TOWN OF ACTON
HISTORIC DISTRICT COMMISSION
472 Main Street, Acton, MA 01720

CERTIFICATE 1131

CERTIFICATE OF APPROPRIATENESS

Location of Work South Acton Congregation Church, 35 School St. District: Center West South X

Custom Signs
878.808.4012
Acton, MA

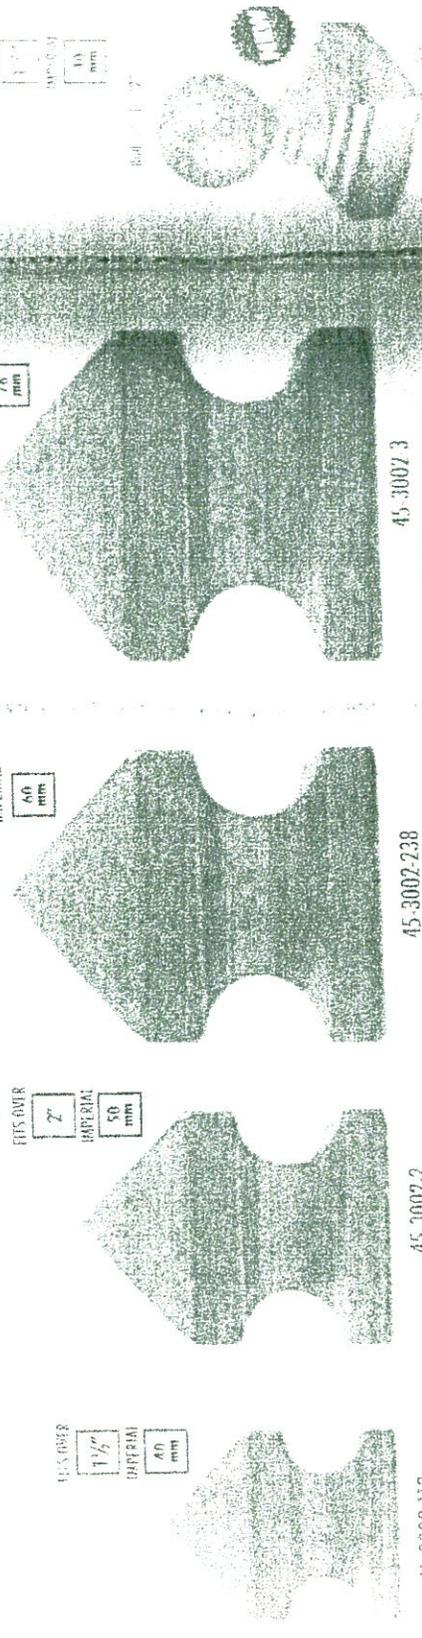
Description of Proposed work: 26" x 42.5" carved wooden freestanding sign with arched top and routed edge. Sign to have white panel and black letters. Routed edgeto be painted to match maroon color border of existing sign. Sign to be mounted on single metal post. Refer to attached artwork for elements of approved sign
Attached sign design approved, with the following conditions:

- Square metal post to be 3" in width – with 45-3002-3 post cap selection as approved by Anita Rogers. Height of post per artwork.
- HDC agrees that sign placement must meet minimum requirement of 60" sideline clearance per zoning, but not necessarily more than this minimum dimension.
- Landscape area to meet requirements of zoning and include evergreen plantings to provide year-round screening of possible future lighting at ground plane.
- SACC to review future light fixtures with HDC if / when selected.
